CBAR Draft Comments on Design Guidelines For the Bethesda Downtown Plan July 14, 2017

Re: Bethesda Downtown Plan Design Guidelines - Comments to Working Draft July 2017

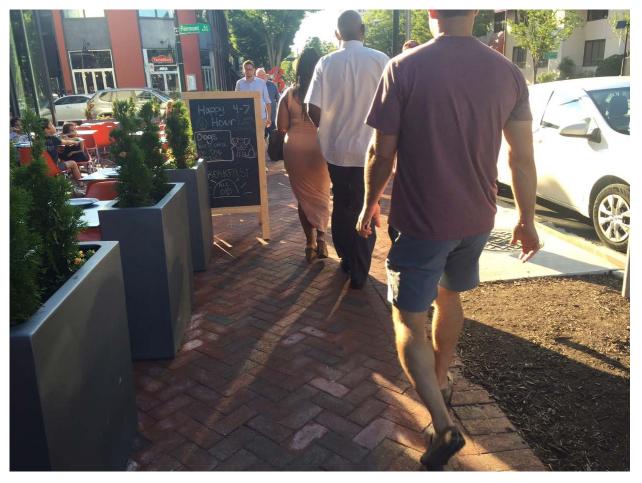
1) I was walking the other evening and thought of a new term for some of the sidewalks in Bethesda. Along the 7770 Norfolk building it literally became a "single file sidewalk." (I semi joked the sidewalk by the trail has become a "slalom sidewalk" for bikers.)

Along those lines I am very concerned what will happen with the new Marriott building if they are not required to significantly increase the width of the sidewalk along Norfolk (and bury the powerlines along the whole block). There is a "single file" corner there that is already busy. We could end up with one of the tallest buildings in the County with one of the smallest corners.
